VIRGINIA ELECTRIC AND POWER COMPANY  
RICHMOND, VIRGINIA 23261

October 18, 1979

Serial No. 819  
LQA/ESG:pwc  
Docket Nos. 50-338  
50-339

LOGIC DIAGRAM - UNIT 2 ALARM FOR 320F-340F OPERATION

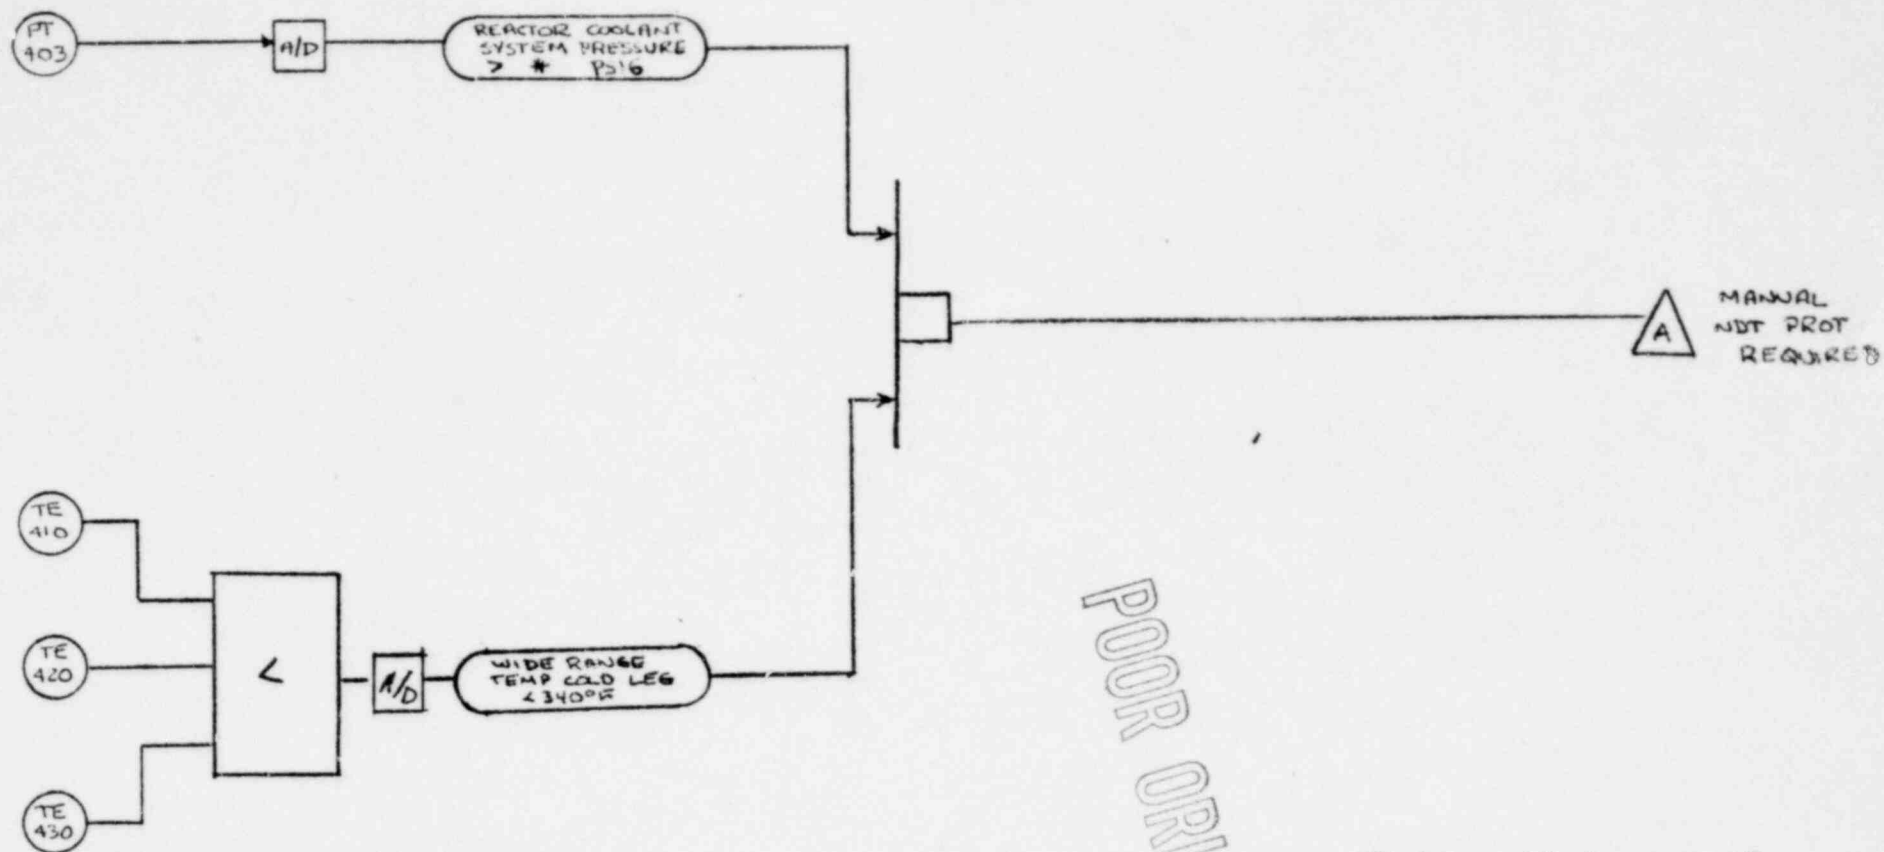
For Reactor Coolant System temperatures between 320°F and 340°F, we have proposed (on Unit 2) that maximum pressurizer level be limited, in lieu of requiring both power operated relief valves (PORVs) to be operable. The Staff has indicated that this approach is acceptable, provided that an alarm be provided during this interval to warn the operator that an overpressure event is in progress. Such an alarm, meeting the requirements of the Staff, will be provided on Unit 2 prior to fuel loading. A schematic of the alarm circuitry is attached.

\*To be selected - on basis of  
10 minute operator action time

PT 402 will have same  
arrangement
